Access Compliance Report

Public Rights-of-Way

Intersection ID: 3896	Main Street: DELLFIELD_WY	Cross Street: MALLARD_DR	Location: SE
ADA ID: EBD79488ED09	Ramp Type: Perp	Initial Pass/Fail: Fail	Overall Compliance: No
Severity Score: 22.5			
Codes/Mitigation Info/Possible Solution		Field Measurements/Component Compliance

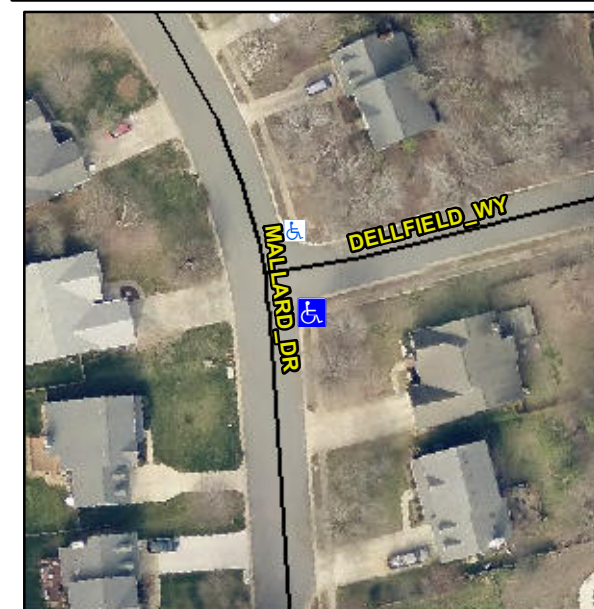
Not Found, R304.5.1, R304.2.2, R304.5.3

Compliance	Description	Data	Compliance	Description	Data
N/A	Ramp Length (in)	66.0	No	Ramp Slope (%)	10.3
No	Ramp Width (in)	38.5	No	Ramp XSlope (%)	3.6
N/A	Flare Type LT	N/A	N/A	Flare Type RT	N/A
N/A	Flare Slope LT (%)	N/A	N/A	Flare Slope RT (%)	N/A
N/A	Flare Traversable LT?	N/A	N/A	Flare Traversable RT?	N/A
N/A	Landing Length (in)	N/A	N/A	DWS Provided?	N/A
N/A	Landing Width (in)	N/A	N/A	DWS Contrast?	N/A
N/A	Landing Slope (%)	N/A	N/A	DWS Length (in)	N/A
N/A	Landing X Slope (%)	N/A	N/A	DWS Full Width?	N/A
N/A	Landing Curb? (Y/N)	N/A	N/A	DWS Offset (in)	N/A
N/A	Shared Landing?	N/A			
N/A	Gutter Ponding?	N/A	N/A	Gutter Slope (%)	N/A
N/A	Gutter Lip Ht (in)	N/A	N/A	Gutter X Slope (%)	N/A
N/A	Painted X Walk1?	No	N/A	Painted X Walk2?	N/A
	X Walk 1 Direction	To N		X Walk 2 Direction	N/A
N/A	X Walk 1 Width (in)	N/A	N/A	X Walk 2 Width (in)	N/A
	X Walk 1 Slope (%)	2.8		X Walk 2 Slope (%)	N/A
	X Walk 1 X Slope (%)	0.7		X Walk 2 X Slope (%)	N/A

Remove & Replace Entire Ramp.
